January 22, 1999
NSD-NRC-99-5822

Subject: Supplemental Response to NRC "Request for Additional Information for Westinghouse Topical Report WCAP-15063-P, 'Westinghouse In-Reactor Creep Model'," dated September 10, 1998.

Supplemental Response to NRC "Request for Additional Information for Westinghouse Topical Report WCAP-15063-P, 'Westinghouse In-Reactor Creep Model'," dated September 10, 1998

Figure 18

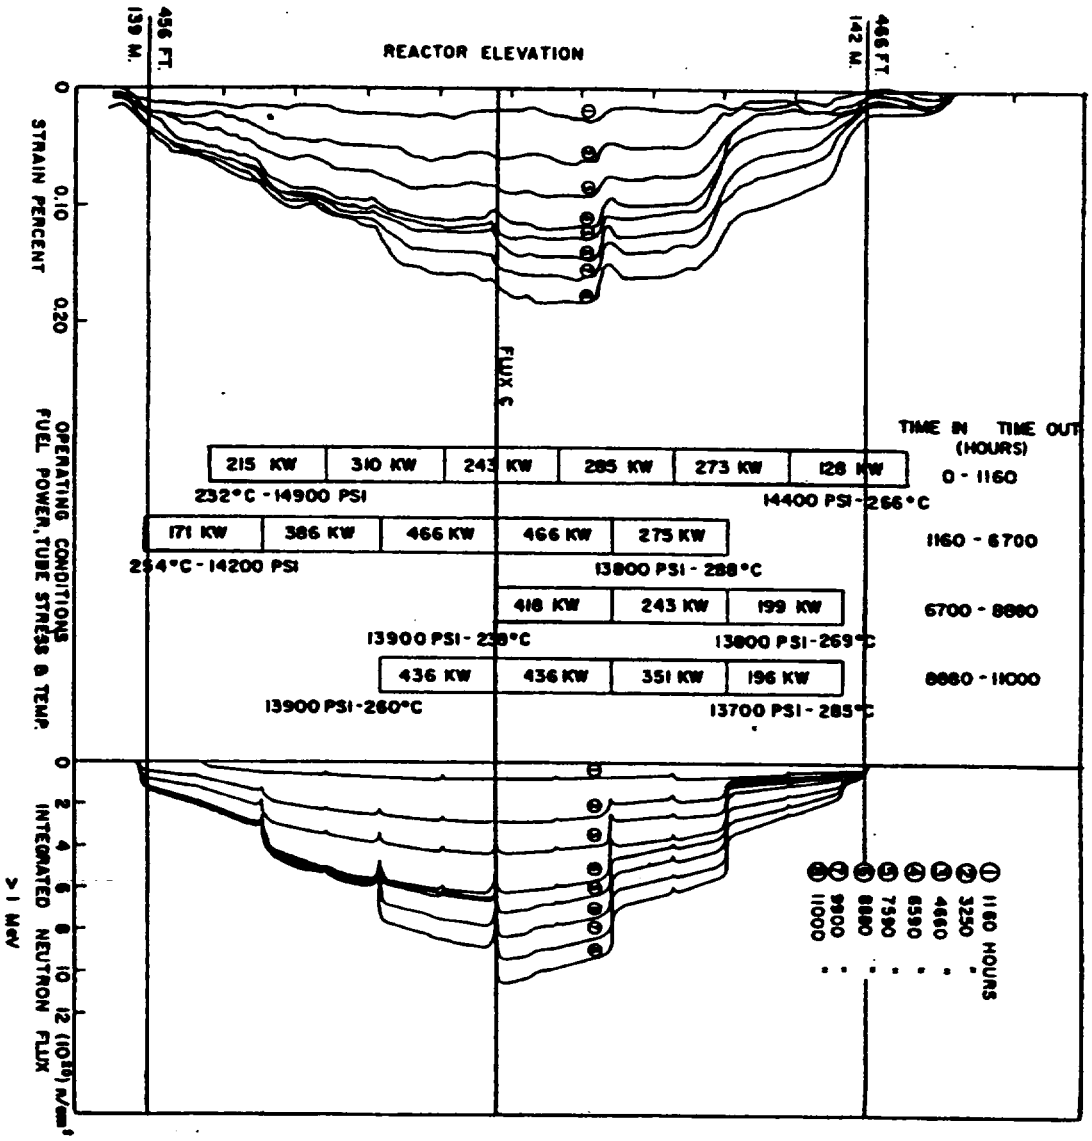
] a, c. The CW Zr-2 pressure tube may be added to WCAP-15063-P by modifying one sentence on Page 11 in the first paragraph of Section 3.2.1.2, adding text just after the modified sentence, modifying Table 3, adding one Figure A, and adding one reference. The sentence to be modified is:

Figure 18

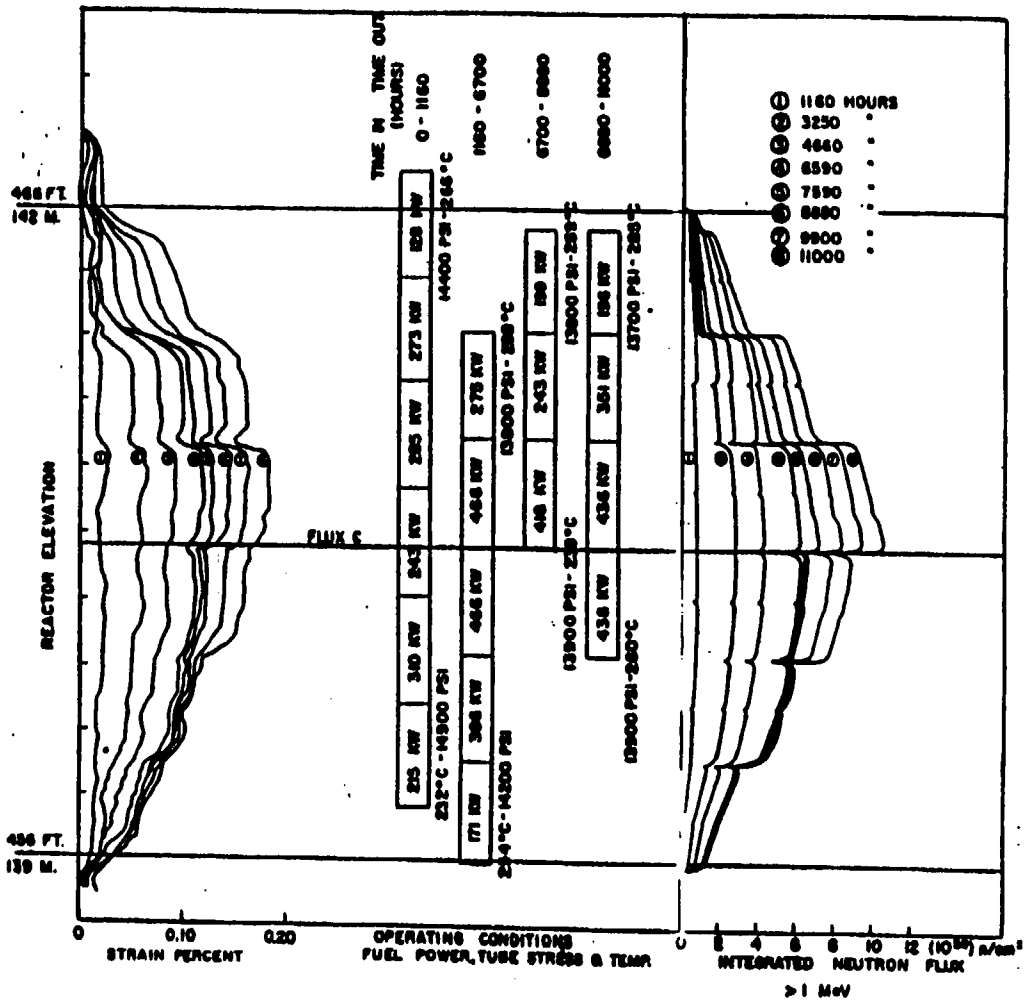
] a,c. The CW Zr-2 pressure tube may be added to WCAP-15063-P, Revision 1, Section 1, by modifying one sentence on Page 11 in the first paragraph of Section 3.2.1.2, adding text just after the modified sentence, modifying Table 3, adding Figure 18, and adding Reference 25. The sentence to be modified is:
